Hydrogen
Pressure
Vessel

New Flange

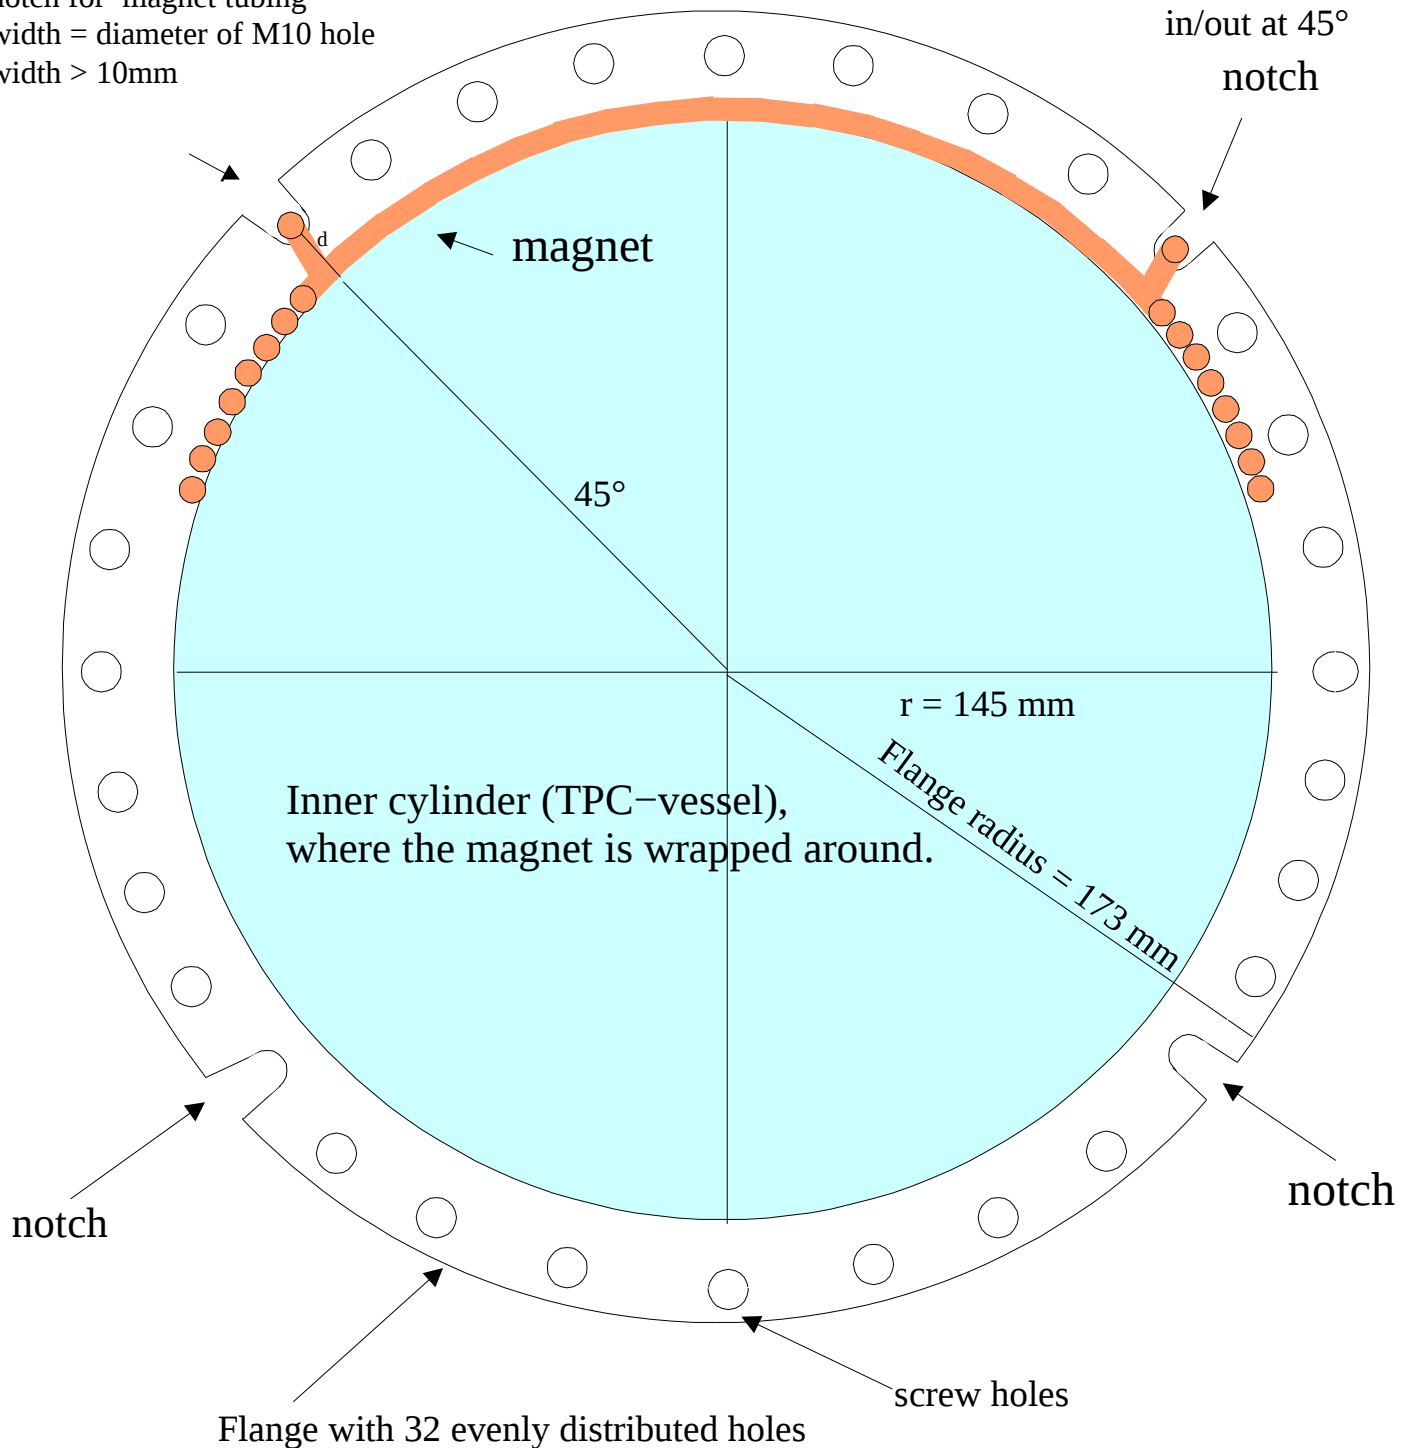
on 4 sides of the flanges
notch for magnet tubing
width = diameter of M10 hole
width > 10mm
